UNITED STATES PATENT AND TRADEMARK OFFICE

APPLICATION NO.	FILING DATE	FIRST NAMED INVENTOR	ATTORNEY DOCKET NO.	CONFIRMATION NO.
09/986,956	11/13/2001	Manuel Barbosa	11017-0006	6385
22902	7590	06/23/2005	EXAMINER	
CLARK & BRODY 1090 VERMONT AVENUE, NW SUITE 250 WASHINGTON, DC 20005			NGUYEN, XUAN LAN T	
			ART UNIT	PAPER NUMBER
			3683

Dual Leading-Shoe Drum Brake
Barbosa
U.S. Serial No. 09/986,956.

FIG. 2 PROPOSED

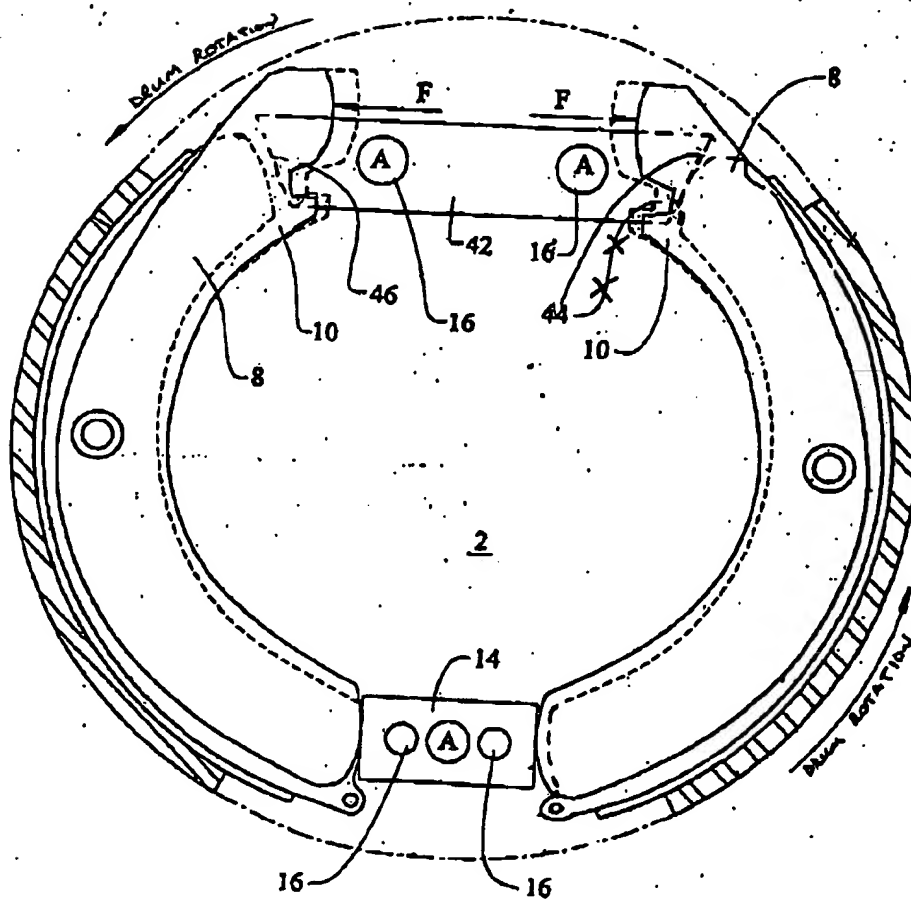
1. The proposed two sheets of figure 2, submitted on 3/28/05, are not approved because the faxed copies are of poor quality; and the proposed changes are very hard to see.

NOT approved
XLN
6/18/05

FIG. 2

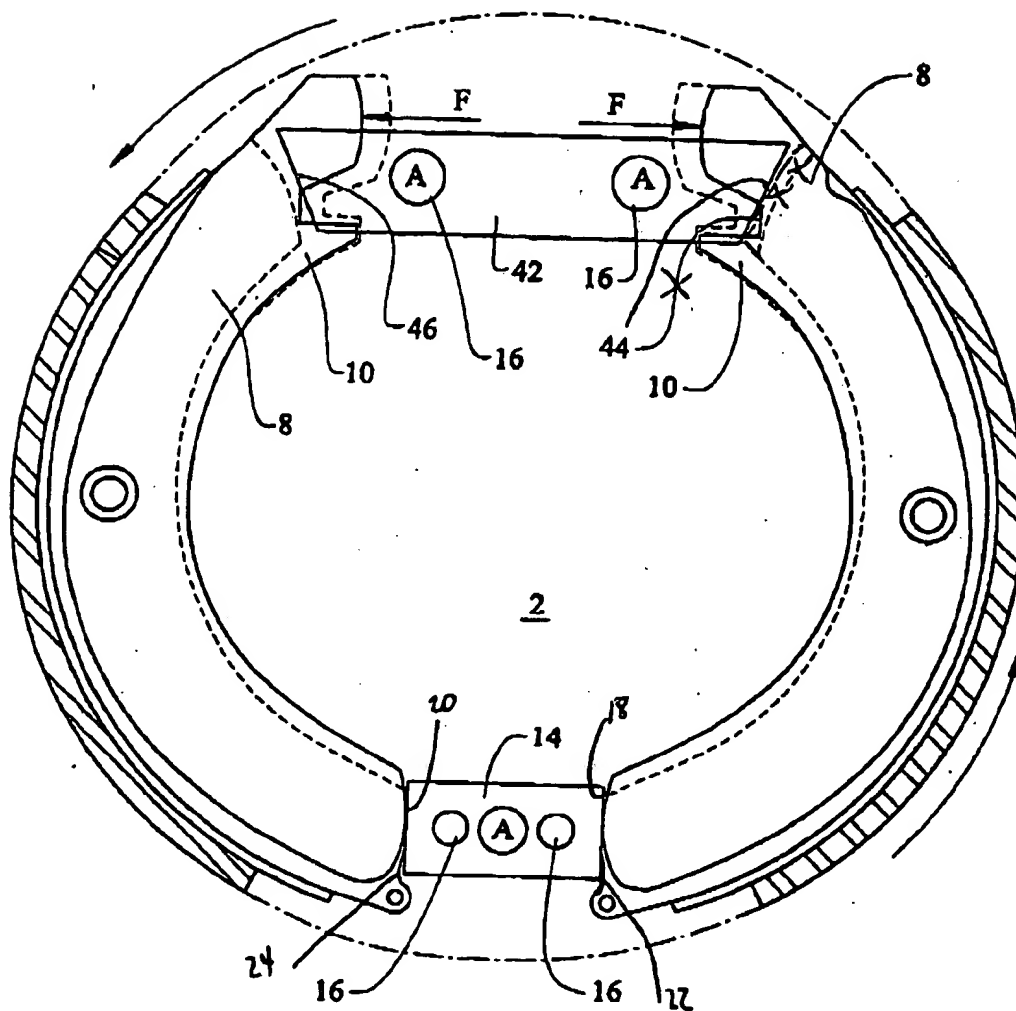
NOT approved
6/18/05
XLN
